SUBJECT: Forwards responses to NRC 810821 ltr requesting info re  
 pressurized thermal shock. Detailed rept will be submitted  
 by 820115.

Subject: Oconee Nuclear Station, Unit 1  
Docket No. 50-269  
Pressurized Thermal Shock

Response to NRC letter dated August 21, 1981  
Request for Information

# ENCLOSURE I

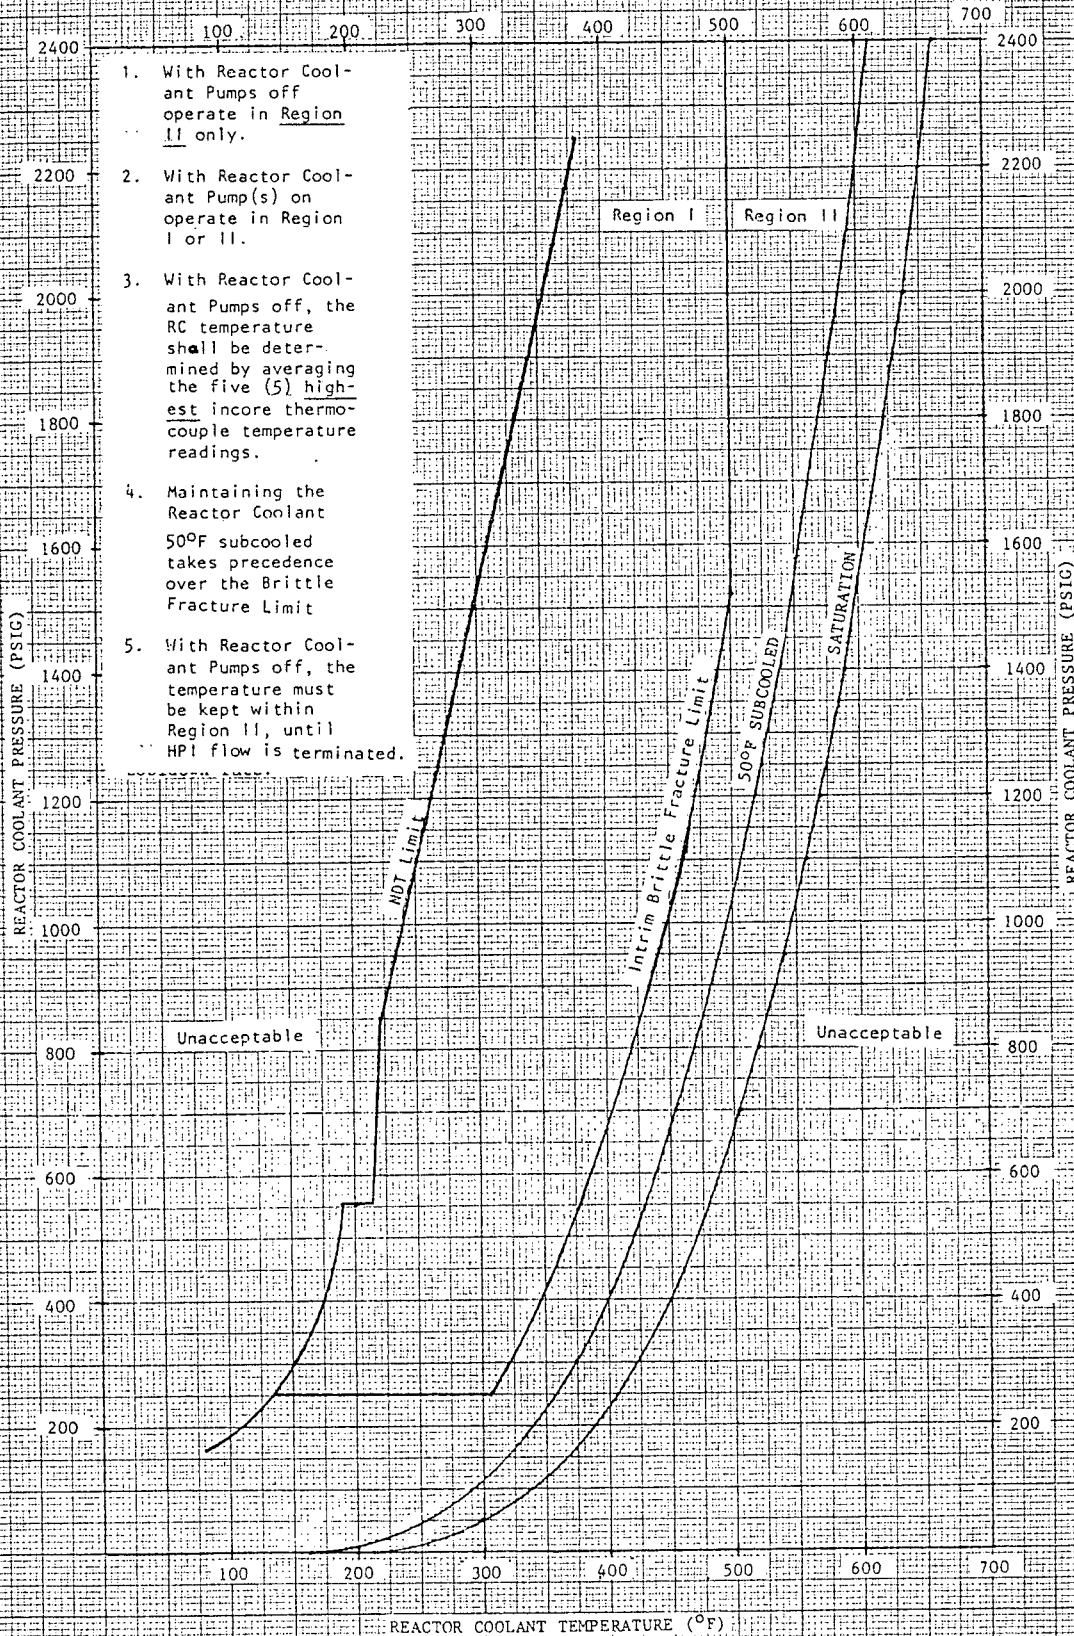
For the loss of coolant, the emergency procedures provide for HPI throttling and termination. Throttling of HPI flow is permitted, if the RCS is 50°F subcooled, to keep the reactor coolant system (RCS) pressure/temperature in the appropriate region of the attached curve (Enclosure 1). If the High Pressure Injection system actuated because of low RCS pressure, it is required to remain in operation until one of the following criteria is satisfied:

- 1) The LPI System is in operation and flowing at a rate in excess of 1000 gpm in each line and the situation has been stable for 20 minutes; or
- 2) All hot and cold leg temperatures are at least 50°F below the saturation temperature for the existing RCS pressure (see Enclosure 1), and the action is necessary to prevent the indicated pressurizer level from going off scale high.

1. With Reactor Coolant Pumps off operate in Region II only.
2. With Reactor Coolant Pump(s) on operate in Region I or II.
3. With Reactor Coolant Pumps off, the RC temperature shall be determined by averaging the five (5) highest incore thermocouple temperature readings.
4. Maintaining the Reactor Coolant 50°F subcooled takes precedence over the Brittle Fracture Limit
5. With Reactor Coolant Pumps off, the temperature must be kept within Region II, until HPI flow is terminated.
